**RE: Arboricultural Assessment of Supporting Removal of Tree 130 Sydney Red Gum:  
MP10\_0016 - "The Terraces" 2 Cooper Street, Paddington**

**Ref: 246MonTree130[AR-RE-P-1008]**

**1. Background**

**Excerpt from Survey Ref: 10358, July 2006 by Clement & Reid.**

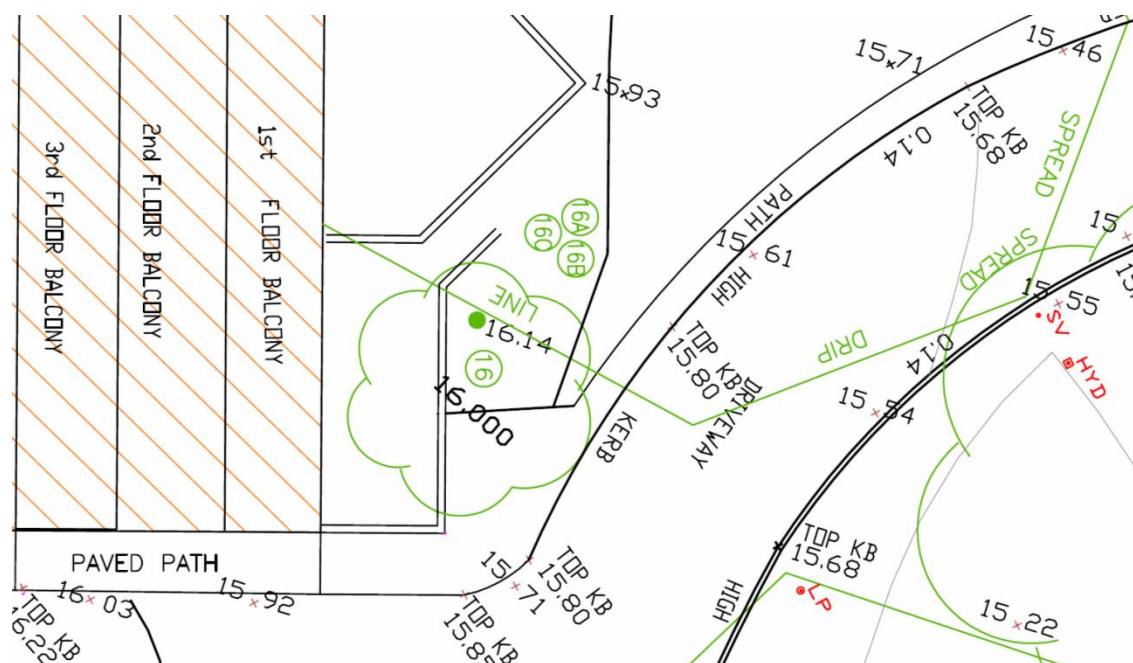
The assessment of the impact of the proposed building works on the tree in the Arboricultural Impact Assessment report for the DA (Ref: 246DAIA, September 2010) was in error. The close proximity of the trunk of the tree to the proposed Driveway ramp to the basement was not accurately assessed. The earlier tree number (#16) on the Survey was misinterpreted by some as the trunk of the tree. The actual trunk centre is at ERL 16.14 as indicated.

Excerpt from *Site Plan, DA101 Rev. P11* by JPRA.

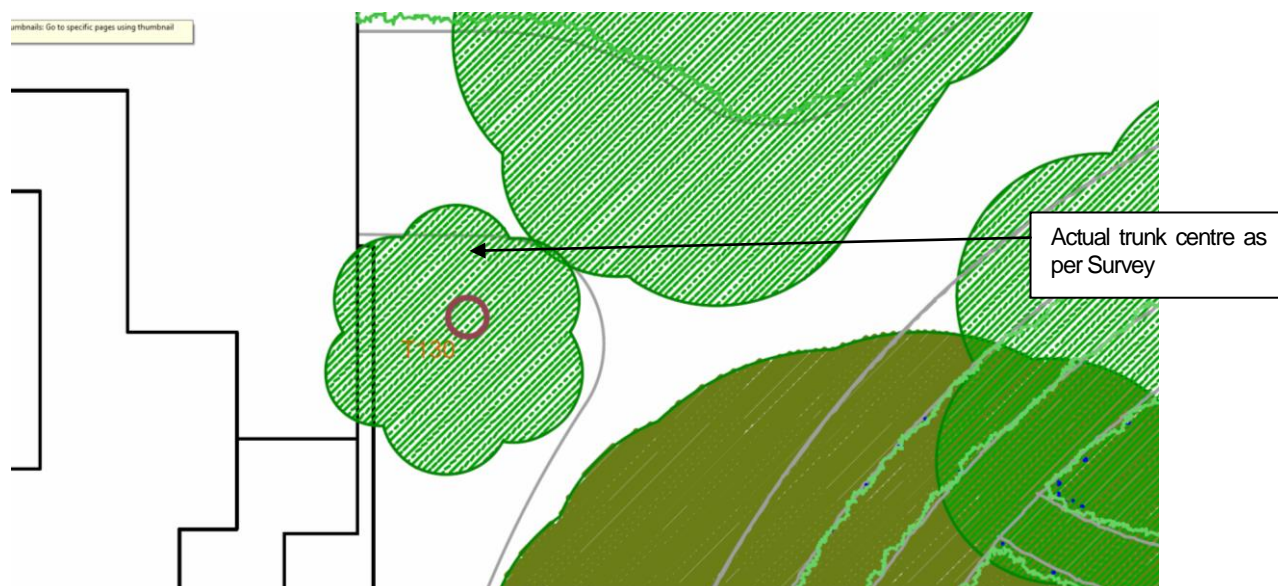
The JPRA Architectural set, Rev. P11, 7.09.10 reviewed for the AIA, September, 2010 had the trunk shown as the tree number rather than the trunk centre, marginally further from the proposed ramp than shown on the current Drawings.

Excerpt from *Level 01 Plan A-P-1103, Rev 10* by JPRA. Refer to Attachment C of detail of Sections 1 and 2.

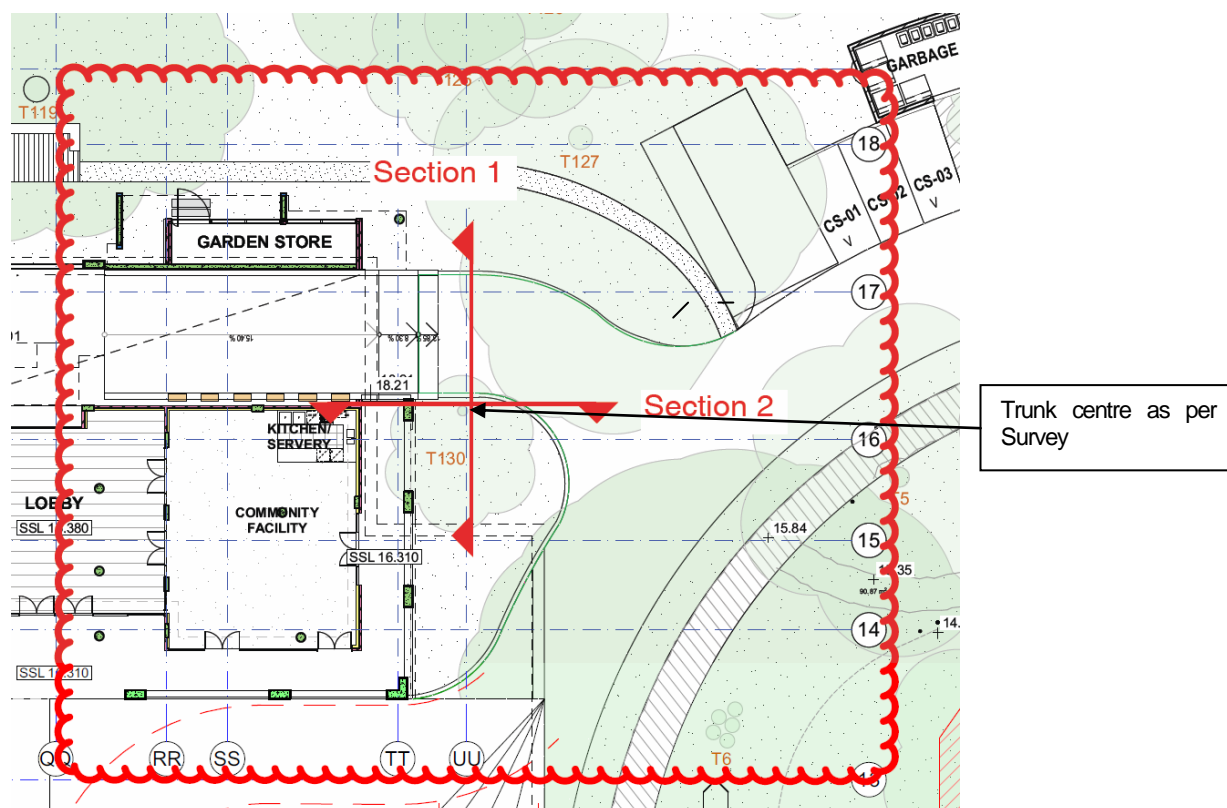
The current construction drawings show the actual trunk location well within the Structural Root Zone (SRZ) (2.8m) of the tree. In fact the excavation needed for the Driveway ramp down to the Basement is within 1m of the base of the tree and will result in root cutting on the tension side of the tree.

Section 1 shows the existing ground lines and proposed cut required for the Driveway ramp. Substantial cut for the proposed Driveway ramp is required at the base of the trunk to the west well inside the SRZ. Section 2 shows the cut required for the Basement (Grid line 15) within the Tree Protection Zone (TPZ) (7.2m) and excavation for the Basement (Grid line TT) within the SRZ. The tree will be destabilised by these combined excavation works within the SRZ, particularly given the lean of the tree away from Driveway ramp line of cut.
